Amendments to the Drawings

Remarks/Arguments

Marked up drawing
Serial No. 09/709,237

Fig. 5

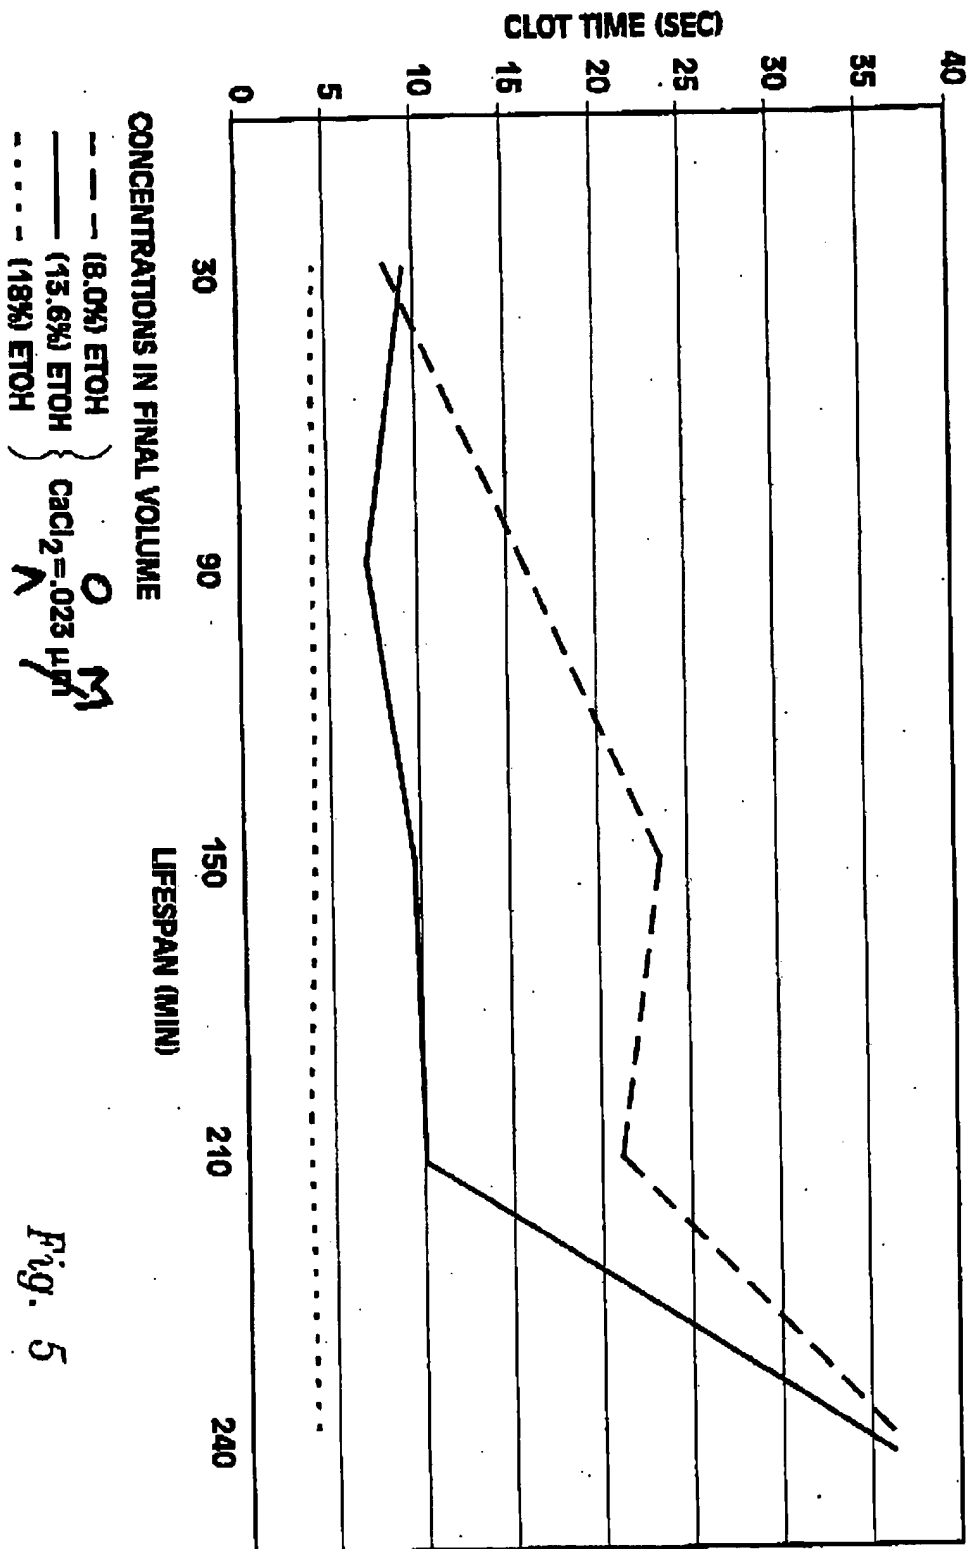
Figs 5 and 6 have been corrected in response to the Examiner's objections, to show the proper abbreviation for micromolar. Figs. 5 and 6 now read " μM " instead of "mM."

Applicants have also amended Figs. 5, 6, 7, 8, 9, 10, and 11 to refer to "0.023", "0.011", and "0.045" instead of "023", ".011", and ".045", respectively to add a "0" in the ones column for clarity and ease of reading.

The Examiner has objected to Figs. 5 and 6 on the grounds that they refer to the concentration of calcium chloride in units of " μm " which is an incorrect abbreviation for micromolar (μM). (Office Action, page 3, paragraph 6). Applicants appreciate the Examiner's notation of this error. Applicants have corrected Figs. 5 and 6 to read " μM "

Fig. 7

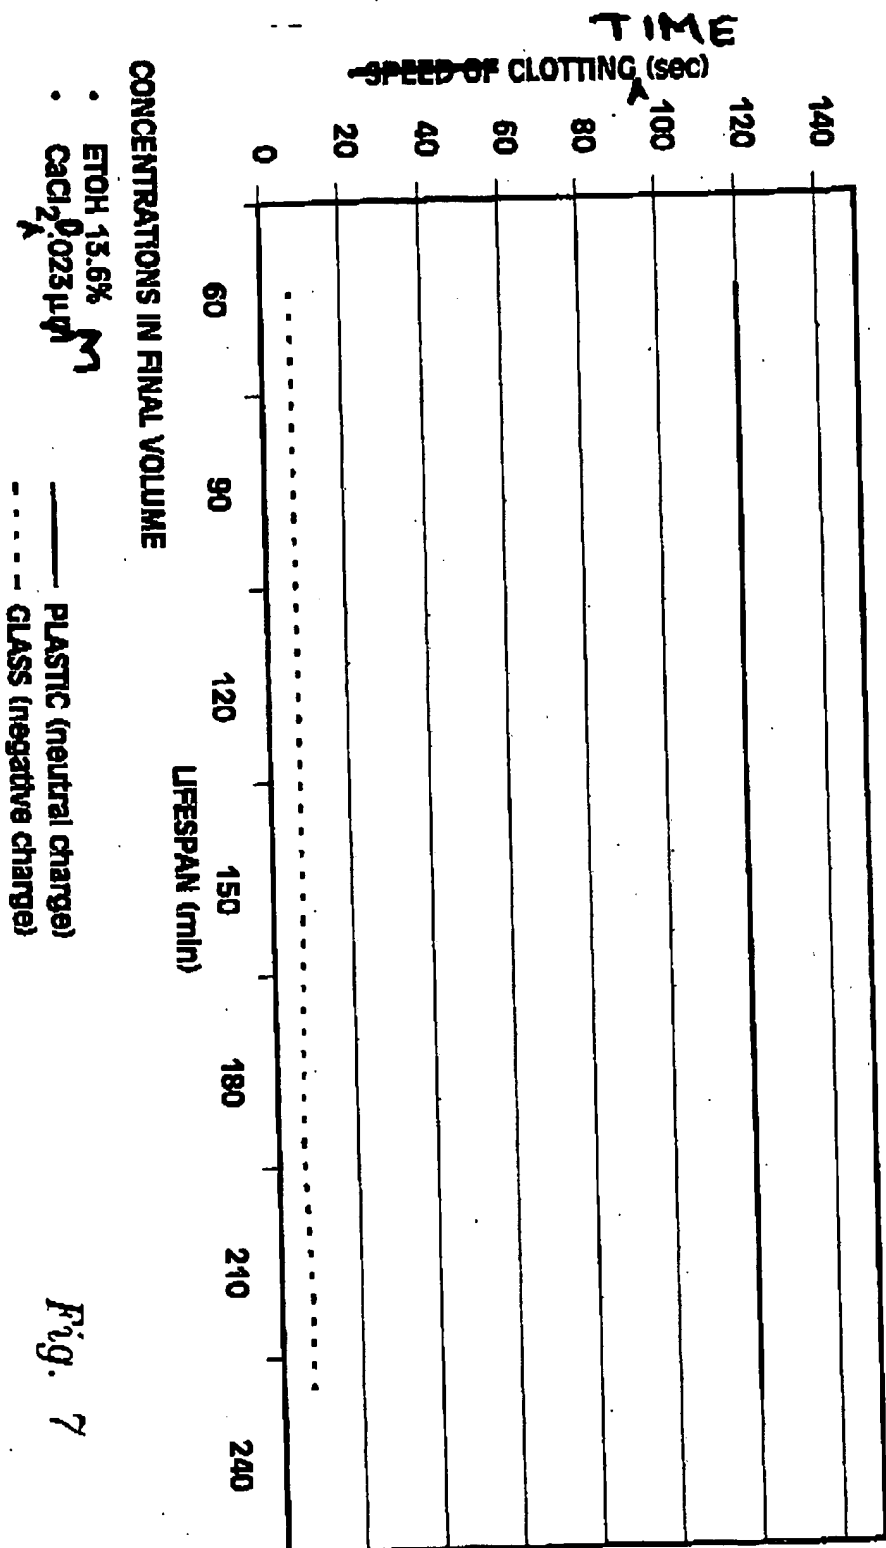
In addition, applicants have corrected Figs. 7, 8, 9, 10, & 11, which also contain the same error. These figures now read " μM " instead of "mM."

Applicants have amended the title of Fig. 7 to change "clotting speed" to "clotting time." Fig. 12 has also been amended to add a label to the Y axis of "Clotting Time (Sec)", which was inadvertently omitted in the submission of formal drawings.

In addition, applicants have corrected the title of Fig. 7 to change "clotting speed" to "clotting time" and Fig. 12 to add a label to the Y axis of "Clotting Time (Sec)". The omission of the label on the Y axis of Fig. 12 was an inadvertent omission in the submission of formal drawings, as Fig. 12 as originally submitted included this label.
